**Proposed Access (Inclined Lift) for the Existing Residential Development
in “Green Belt” and “Residential (Group C) 1” Zones
at No. 17 Bowen Road, Mid-Levels, Hong Kong
(Planning Application No. A/H12/30)**

- Further Information No.1 -

(Application No. A/H12/30)

Figure 2.1: Site Location Plan

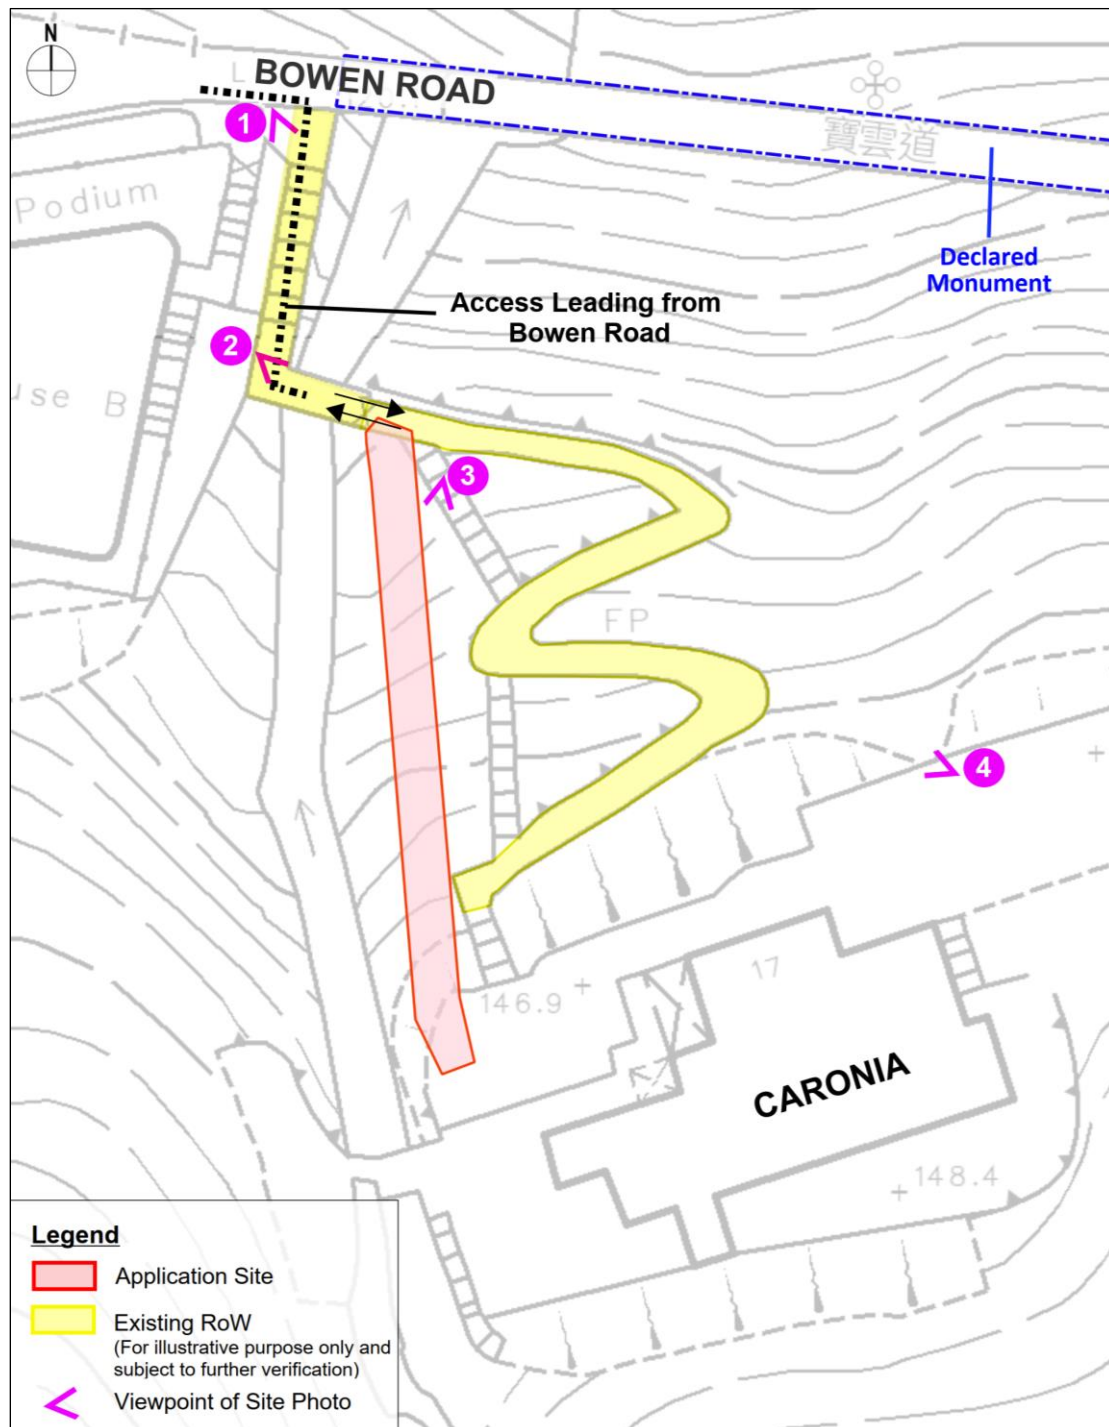
Comments	Responses						
Comments from Hong Kong District Planning Office, Planning Department (Contact Person: Mr. Ronald CHAN; Tel: 2231 4913)							
(1) The existing ROW illustrated in Figure 2.1 of the Planning Statement is different from the ROW on the lease plan. Please rectify. Please also explain whether the original ROW would be surrendered/replaced by the proposed inclined lift system. And the current staircase on G.L. would be re-instated.	The current proposal is intended to facilitate the re-alignment of existing RoW, which will be partially replaced by the proposed inclined lift and existing staircase. Details of the re-alignment proposal are subject to further discussion and negotiation with relevant B/Ds in the subsequent land administration stage. The extent of ROW has been updated in Figure 2.1 and 2.3. (Annex A refers)						
(2) As stated in para 3.1 of the Planning statement, the length of the inclined lift is 32m. Also, as stated in Appendix 3 GPRR, the application site is 2.4m in width and 38m in length. Please explain the reasons to position the lower end of the inclined lift track at +127.6mPD, how it is qualified as a barrier-free access, and the total site area.	Noted. Para 2.1 of GPRR has been updated. With the intention to minimise any potential impact on the declared monument (i.e. 21-Arch Section of the Bowen Aqueduct), the lower end of the inclined lift track is strategically positioned away from Bowen Road and located adjacent to the existing gate alongside the RoW. This is to provide easier access to the Caronia, but not to fulfil any statutory or non-statutory regulations on BFA provision. The current proposal strikes a balance between accessibility & convenience and preservation of declared monument, whilst addressing TPB's previous concerns. (Annex B refers)						
(3) With reference to the inclined lift system at Tai O Heritage Hotel mentioned in the GPRR, the applicant is required to provide further information on the necessary facilities/installations of the proposed inclined lift (e.g. dimension of landing platforms, gross dimensions of the lift compartment together with maintenance footpath and boundary fences alongside the lift track, etc.), and thus the total area required.	Details of necessary facilities/installations of the Proposed Inclined Lift are as follows:
